Serial No. 04-270
ESP/JDH
Docket No. 52-008

DOMINION NUCLEAR NORTH ANNA, LLC
NORTH ANNA EARLY SITE PERMIT APPLICATION
RESPONSE TO REQUEST FOR ADDITIONAL INFORMATION NO. 3

Response to NRC RAI Letter No. 3

Figure 1. Map showing general area of coverage of Obermeier and McNulty (1998) liquefaction study relative to interpretations of the Central Virginia Seismic Zone.

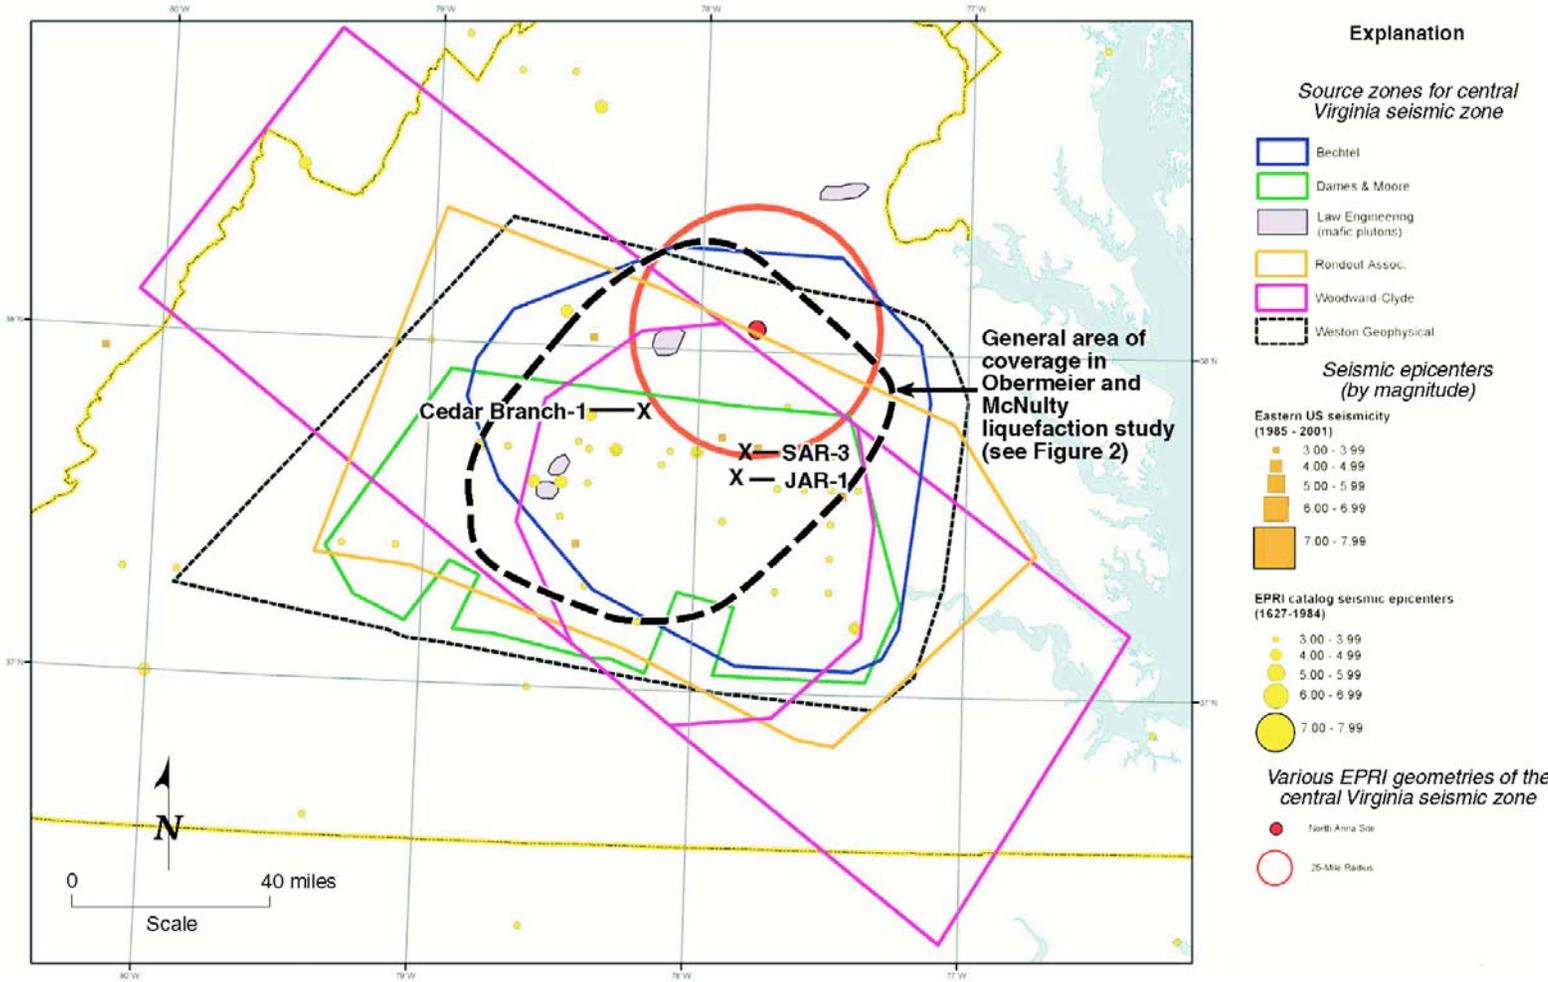
- c) Considering that the CVSZ is the major contributor to the hazard at the ESP site, please provide the following additional information:
 - i) a map showing the locations of the paleoliquefaction features relative to the ESP site,
 - ii) evidence that supports the stated ages of the liquefied sediments,
 - iii) specific locations, dimensions, and characteristics of the liquefaction features, and
 - iv) extent of the CVSZ covered by the study.

Location. A map showing the general area covered by the Obermeier and McNulty, 1998 study relative to the location of the North Anna site and the Central Virginia Source Zone as identified by the EPRI teams is shown on Figure 1. [Figures are located at the end of the RAI response.] A detailed map showing the locations of rivers canvassed by Obermeier and McNulty (1998) in relation to the North Anna ESP site is shown in Figure 2. This figure is modified from a figure produced by Obermeier for presentations, but never published. Figure 2 shows the locations of the liquefaction features identified during the study, as well as the locations of exposures of middle to late Holocene liquefiable deposits along rivers that did not contain liquefaction features. In general, more than 300 kilometers of rivers were examined by canoe in the summer of 1997 following a severe drought that revealed extensive exposures of stream banks that are rarely exposed. In recent discussions however, Dr. Obermeier indicated that parts of the North Anna River were surveyed following a rainstorm, such that high water submerged many exposures along the river and prevented continuous evaluation. As shown on the map, the liquefaction study area included many river segments over a broad regional area encompassing a large part of the CVSZ as identified by the EPRI teams.

Figure 1. Map of the East Coast fault system (ECFS, thick black lines), taken from Marple and Talwani (2000). CFA = Cape Fear arch; NFA = Norfolk Arch.

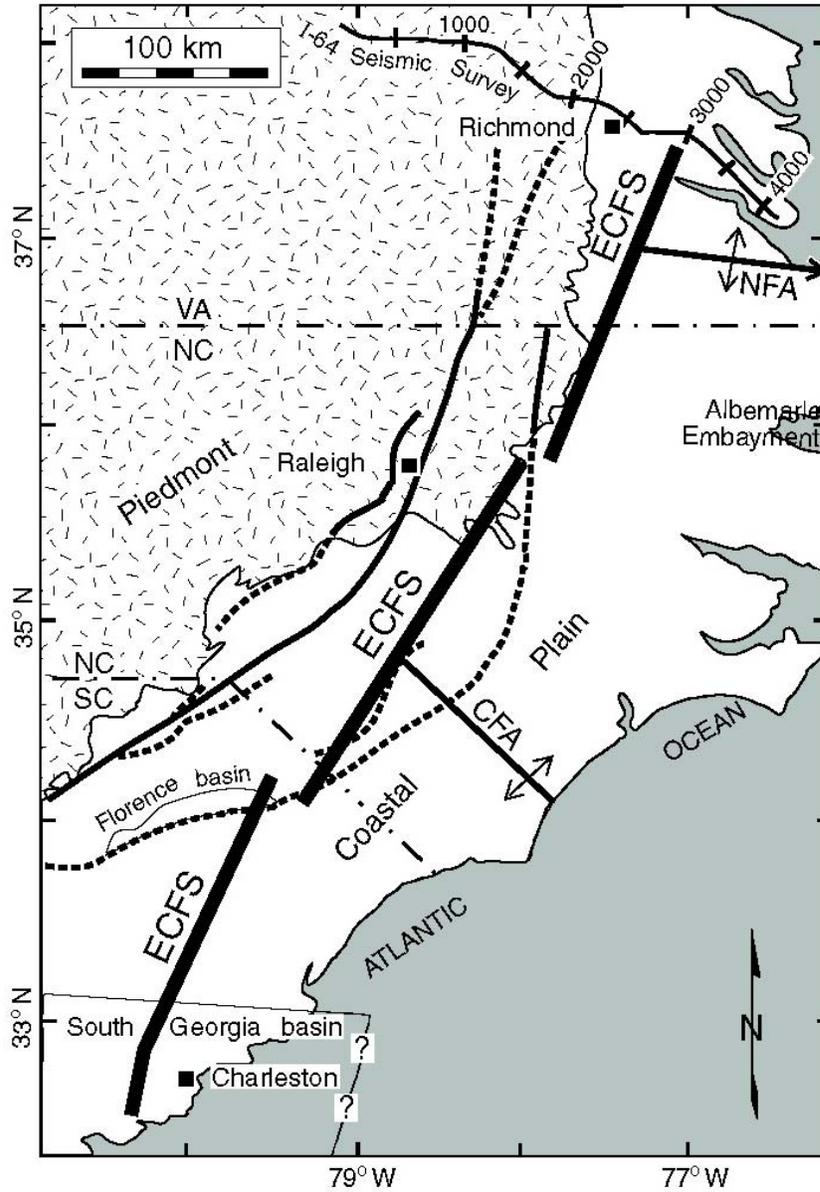
In SSAR Section 2.5.1.1.4, Dominion concludes on the basis of several lines of evidence, including aerial reconnaissance, that the northern segment of the East Coast Fault System (ECFS) “probably does not exist or has a very low probability of activity if it does exist.” Please provide additional information on the nature of the aerial reconnaissance for the ECFS, including the area covered and the type of evidence used to conclude that the northern segment of the ECFS does not exist or has low probability of activity. Please explain how information gathered during the aerial reconnaissance and from other sources supports conclusions in the SSAR that appear to be inconsistent with those made in the detailed geomorphic analysis of Marple and Talwani (Reference 74).

Marple and Talwani (2000) draw on geological, geophysical, seismological and geomorphic evidence to support their interpretation of the presence, location and activity of the ECFS. The location of the ECFS as described by Marple and Talwani (2000) is shown in Figure 1. [Figures are located at the end of the RAI response.] A detailed map of the northern segment of the ECFS is shown in Figure 2.

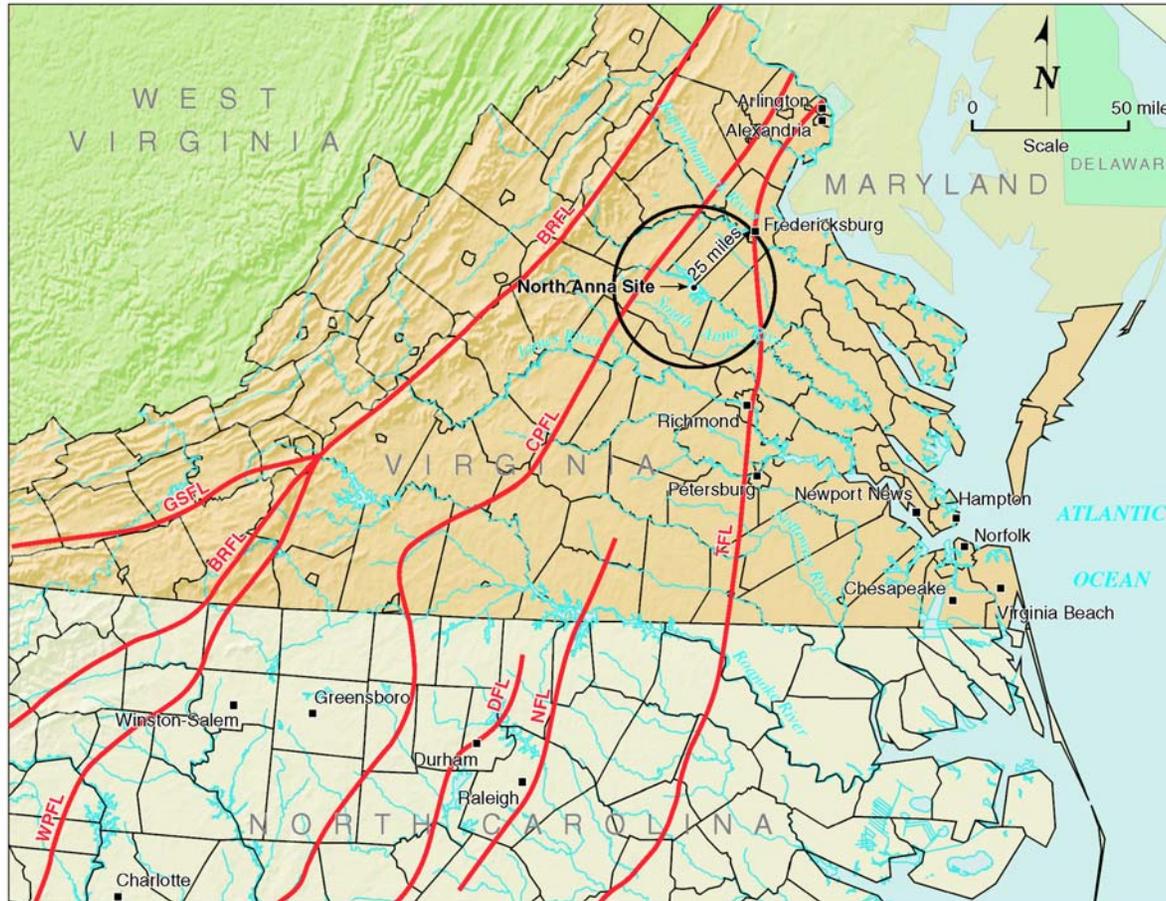
In SSAR Section 2.5.1.1.4, Dominion concludes that the seven fall lines defined by Weems (Reference 70) do not “represent a capable tectonic source.” Weems (Reference 70) favors a neotectonic origin for the seven fall lines. Please provide additional justification to confirm or disprove the seven fall lines defined by Weems (Reference 70) as a capable tectonic source. Also, please explain how the absence of these features in the compilation of Crone and Wheeler (Reference 59) demonstrates that the fall lines are not capable tectonic sources.

Specifically, the “fall lines” described by Weems (1998) (Figure 1) are not defined by formal, consistently applied criteria, and thus are not as well defined and laterally continuous as depicted. [Figures are located at the end of the RAI response.] For example, different features are sometimes correlated to form a laterally continuous fall line while in other cases similar features are not correlated. Weems (1998) also argued for a neotectonic origin for the fall lines primarily because he concluded that the competing hypotheses (Quaternary climatic variations; differential bedrock erodability) are less compelling. However, Weems (1998) does not present direct credible evidence for a tectonic origin of the fall lines. Based on our evaluation of stratigraphic, structural and geomorphic relations across and adjacent to the fall zones described by Weems (1998), we conclude that differential erosion due to variable bedrock hardness is a viable and more plausible explanation than Quaternary tectonism. Furthermore, there is no complementary geomorphic expression of tectonism, such as the presence of tectonic escarpments, along the trend of the fall lines between drainages where one would expect to find better preservation of tectonic geomorphic features.

We conducted independent geomorphic analyses of the Tidewater and Central Piedmont fall lines because these two features lie within the North Anna site vicinity (Figure 1). The goals of the analyses were to: (1) confirm the presence and exact location of the fall lines as fall zones on major rivers; and (2) evaluate geologic and geomorphic relationships to determine whether late Cenozoic deformation has occurred along the fall lines, as postulated by Weems (1998). Similar analyses of the other fall lines identified by Weems (1998) were not performed because these features lie outside the 25-mile-radius of the ESP site vicinity (Figure 1).

Figure 1. Sensitivity to ground motion model, 2.5 Hz

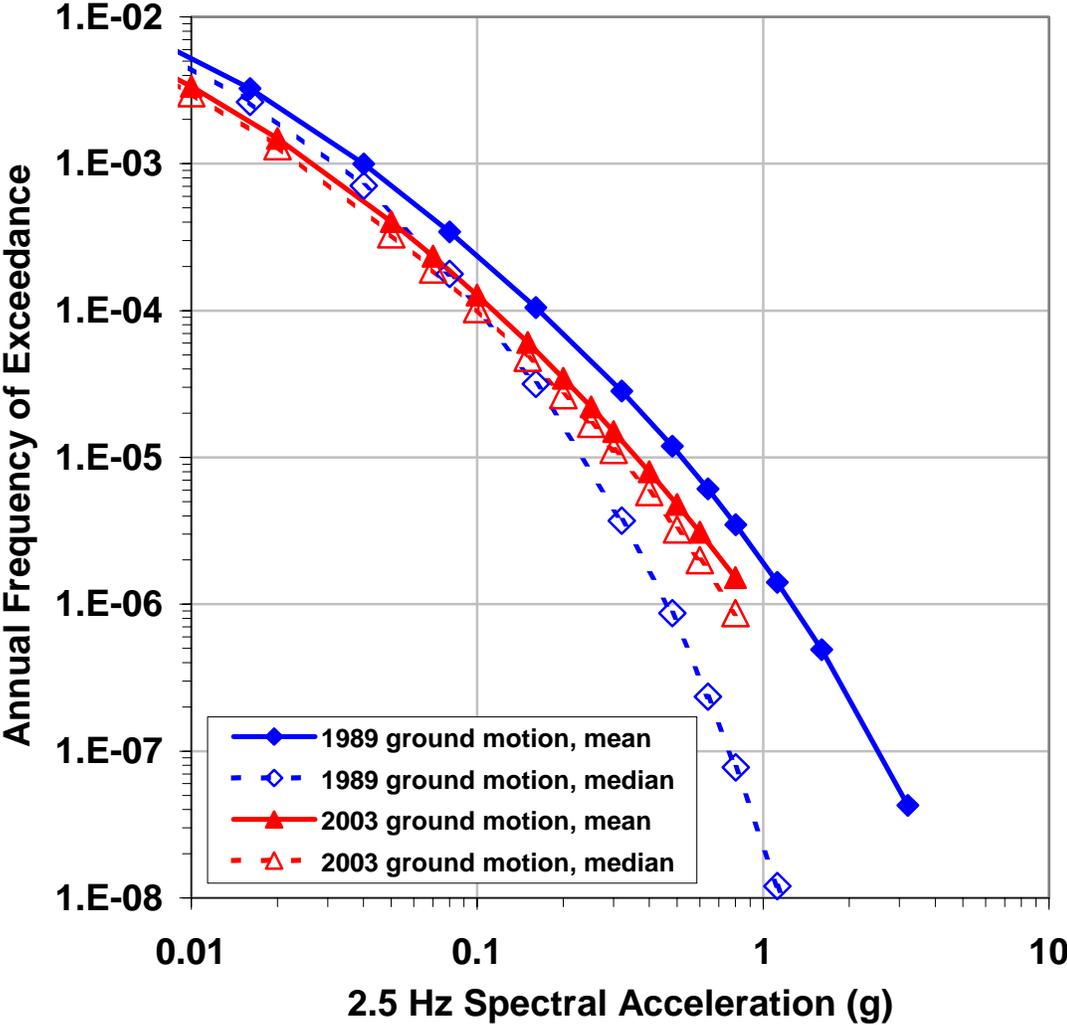
- a) Please provide hazard curves for 2.5 and 5 Hz spectral acceleration similar to those provided in the SSAR for 1 Hz (Figure 2.5-45) and 10 Hz (Figure 2.5-44).

The requested hazard curves are provided in Figures 1 and 2 on the next 2 pages. These curves were calculated just as were the 1 Hz (Figure 2.5-45) and 10 Hz (Figure 2.5-44) curves of the SSAR except that attenuation relationships appropriate for 2.5 Hz and 5 Hz ground motions were used.

Figure 1. Spectrum scaled to 1 and 2.5 Hz using $M=7.5$, $R=500$ km, compared to similar spectrum using $M=5.6$, $R=37$ km, to spectrum scaled to 5 and 10 Hz using $M=5.3$, $R=23$ km, and to performance-based spectrum.

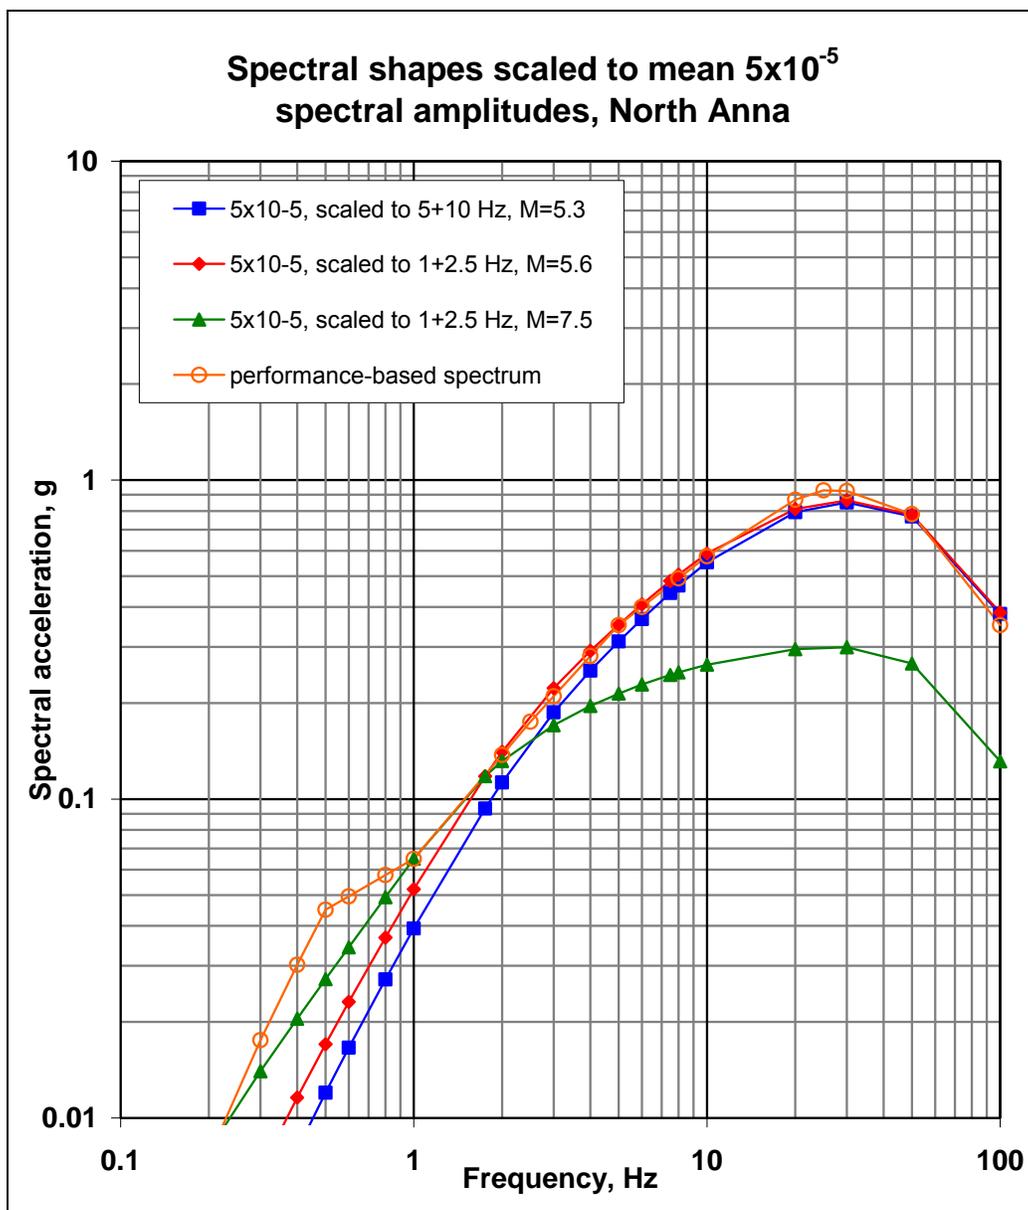
Regarding new seismic source characterizations, SSAR Section 2.5.2.6.3 states that, for the Charleston seismic source, the USGS source parameters (Reference 127) were adopted. SSAR Section 2.5.2.2.9 states that “the most significant impact of the 2002 USGS model (Reference 127) on seismic hazard for the ESP site is the updated Charleston sources parameters.” Figures 2.5-40 and 2.5-41 show 1 Hz spectral acceleration seismic hazard curves (median and mean, respectively) at the ESP site for the northern and southern segments of the East Coast Fault System (ECFS). As shown in both of these figures, the southern segment of the ECFS (ECFS-S), which includes the Charleston seismic source, makes a significant contribution to the overall hazard at the 1 Hz spectral acceleration. In spite of the significant contribution of the ECFS-S for low frequency ground motion, the controlling earthquake for the 1 and 2.5 Hz frequency range is a magnitude 5.5 earthquake at a distance of 30 km from the ESP site (Table 2.5-26). Neither this magnitude nor this distance correspond to an event occurring in the ECFS-S (i.e., Charleston source zone). Please explain this result in view of the statement quoted above and Figures 2.5-40 and 41 in the application.

If a large-magnitude, distant earthquake were to be adopted as a controlling earthquake for low frequencies, the primary effect would be a small increase below the 1-to-2.5 Hz control frequency point in the SSE spectrum. This is illustrated in Figure 1. This plot shows a low-frequency spectrum scaled to the average of the 1 and 2.5 Hz amplitudes for a mean hazard of 5×10^{-5} , using $M=7.5$ and $R=500$ km (the green triangles). The low-frequency spectrum developed in the SSAR used $M=5.6$ and $R=37$ km (the red diamonds in Figure 1), representing the dominant contribution of the central Virginia seismic zone. The selected performance-based spectrum is also shown as orange circles. The $M=7.5$ spectrum lies below the $M=5.6$ spectrum at frequencies higher than 2 Hz, and lies below the selected performance-based spectrum at frequencies between 1 Hz and 0.2 Hz (few, if any, plant components are sensitive to these low frequencies). The high-frequency spectrum developed in the SSAR, which used $M=5.3$ and $R=23$ km (the blue squares in Figure 1), does not affect the SSE in the low-frequency range.

There is significant additional margin above the selected performance-based spectrum provided by the RG1.60 spectrum anchored at 0.3g (see, for example, SSAR Figure 2.5.2-51). Thus, the adoption of a large-magnitude, distant earthquake as a controlling earthquake would not change the seismic design requirements above the selected performance-based spectrum.
